Re: Deficiency of PAP Amendments, Incidental Boundary Change,
Kaiser Coal Corporation, Sunnyside Mine, ACT/007/007-88(A),
Folder No. 2, Carbon County, Utah

Kaiser Coal Corporation submits the following response to your letter of August 15, 1988, regarding deficiencies for the Industrial Boundary Change (IBC) and small area exemptions.

COARSE REFUSE TOE INCIDENTAL BOUNDARY CHANGE / SMALL-AREA EXEMPTION		
DRAWN BY C W W	7-22-88	PLATE III-33 (10)
SCALE 1" = 50'		DRAWING
CONTOUR INTERVAL 5'		B4-0077

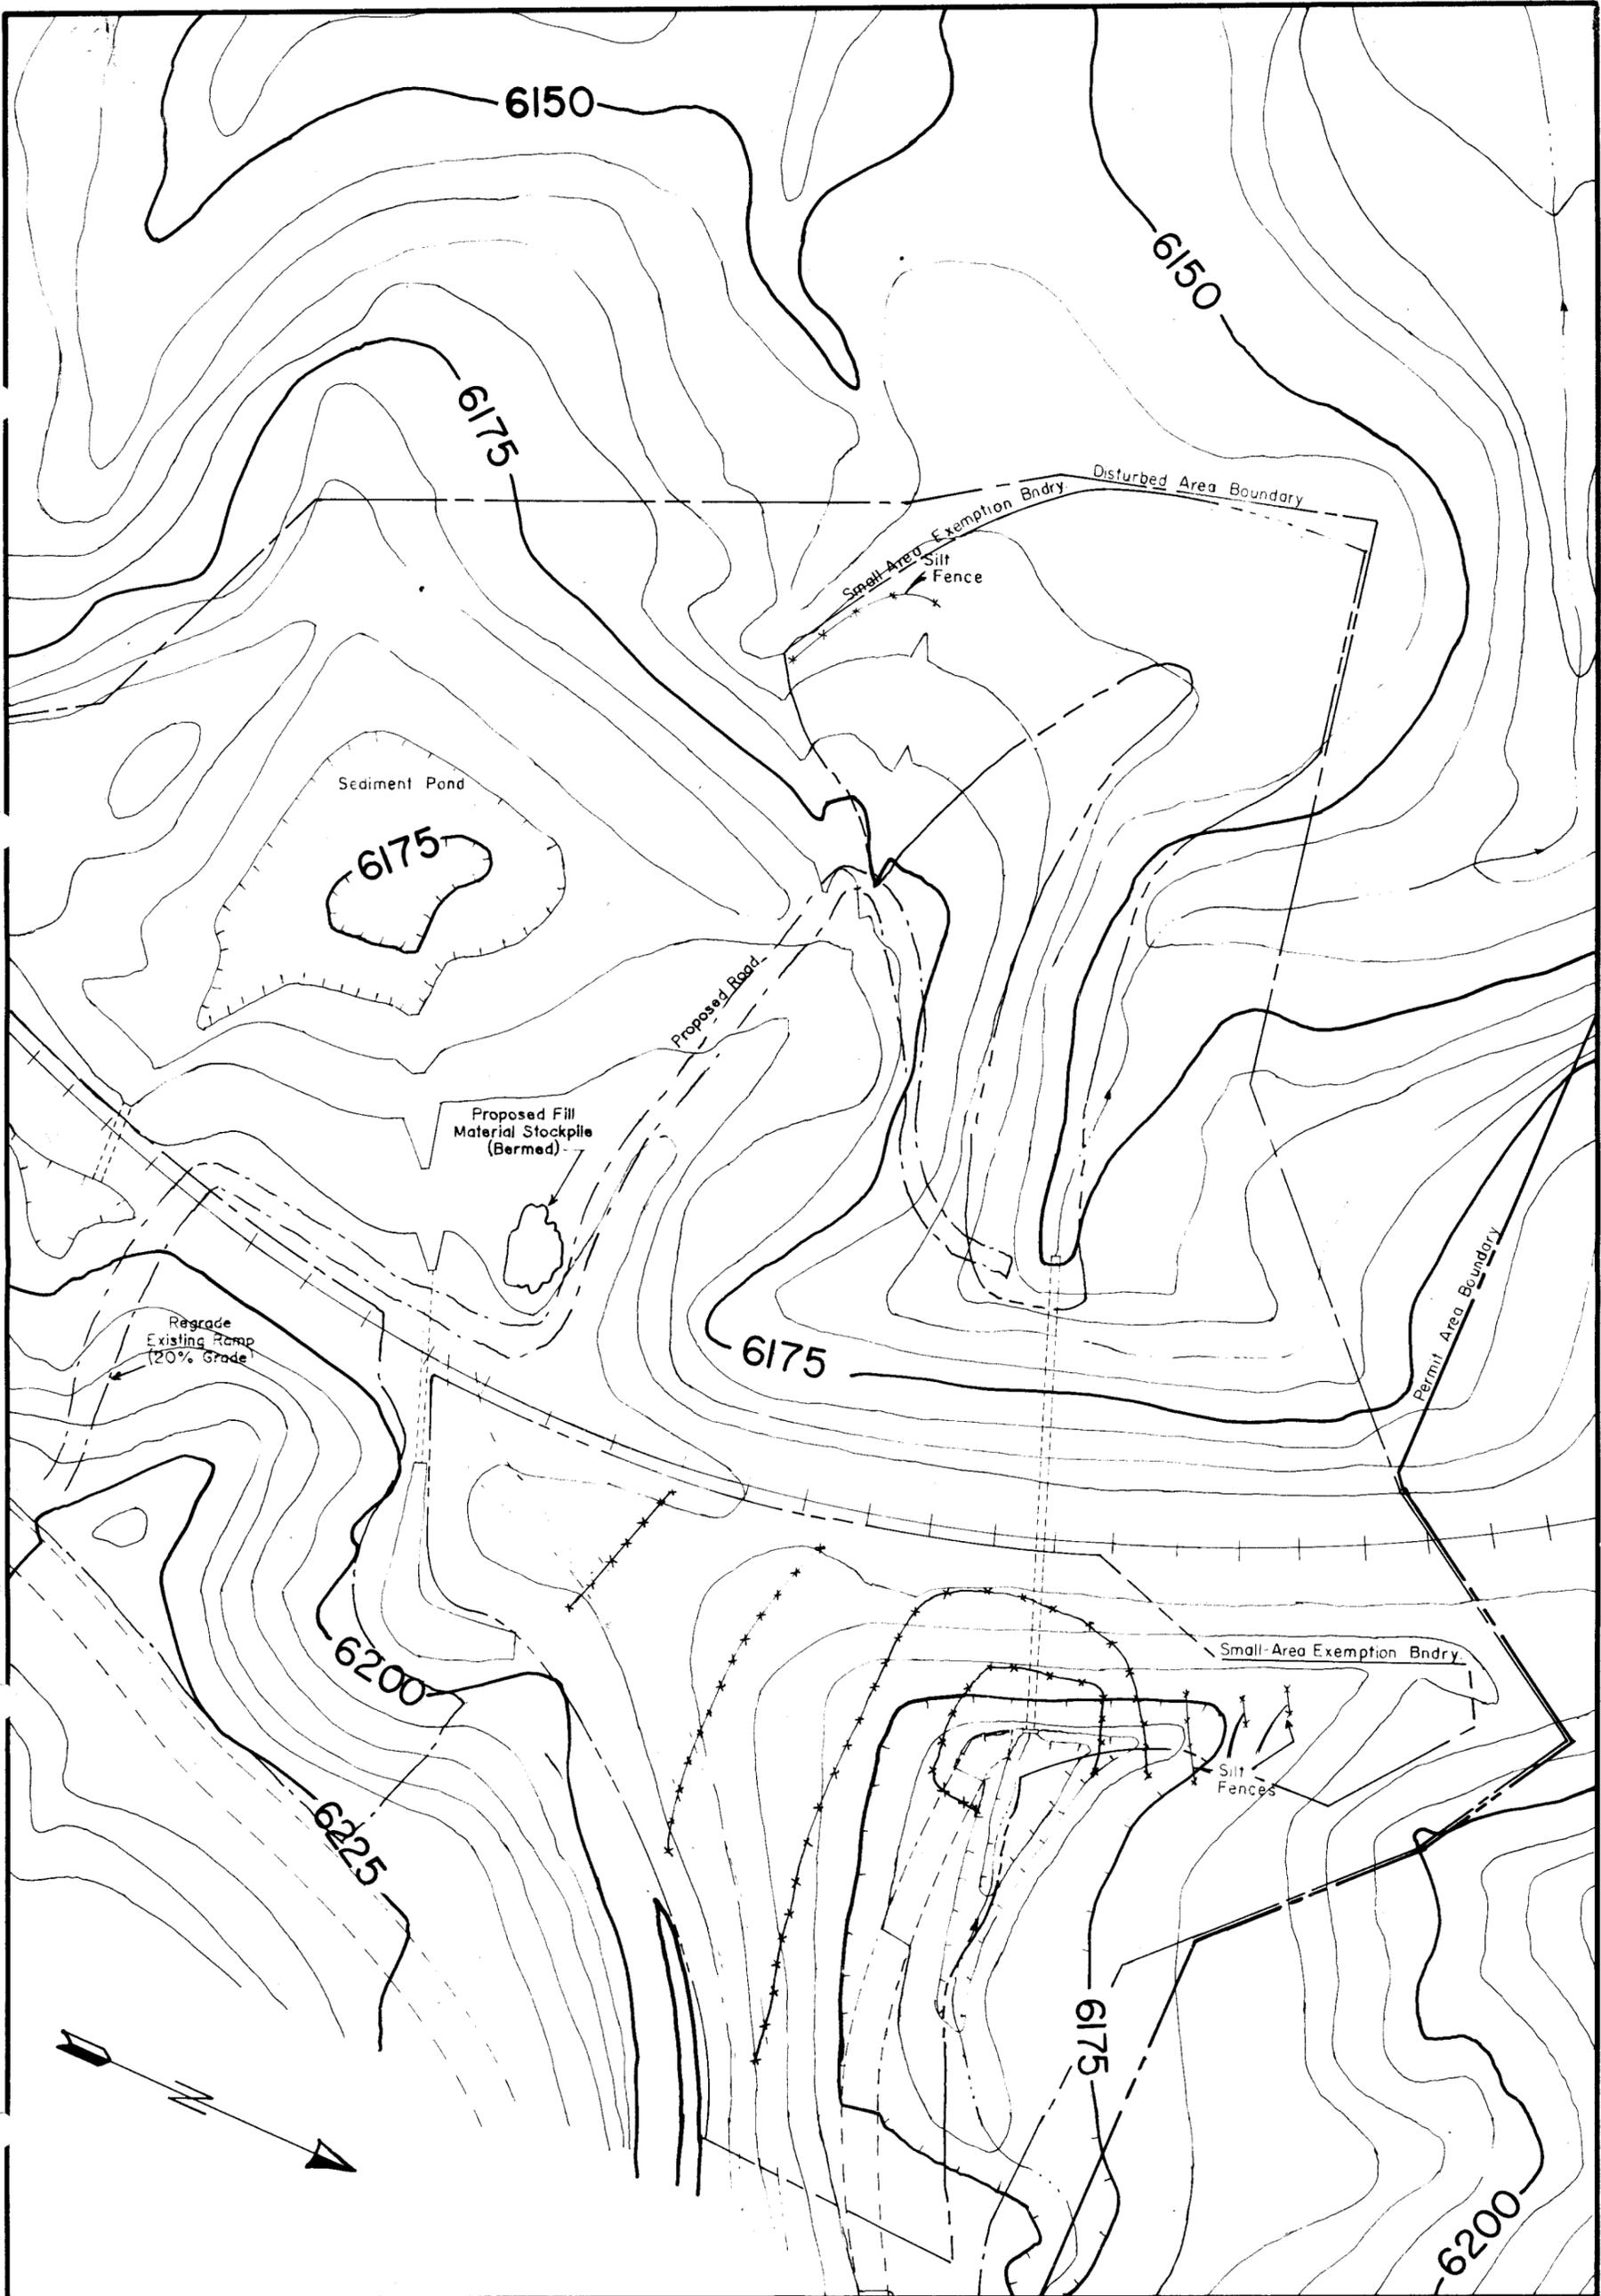
Item 1 - Silt Fence Sedimentation Control for Reclamation of Old Coarse Refuse Toe Pond Area

The silt fence location for the reclamation pond area and the railroad culvert inlet are shown on Plate III-33 (10). These locations can be considered as built.
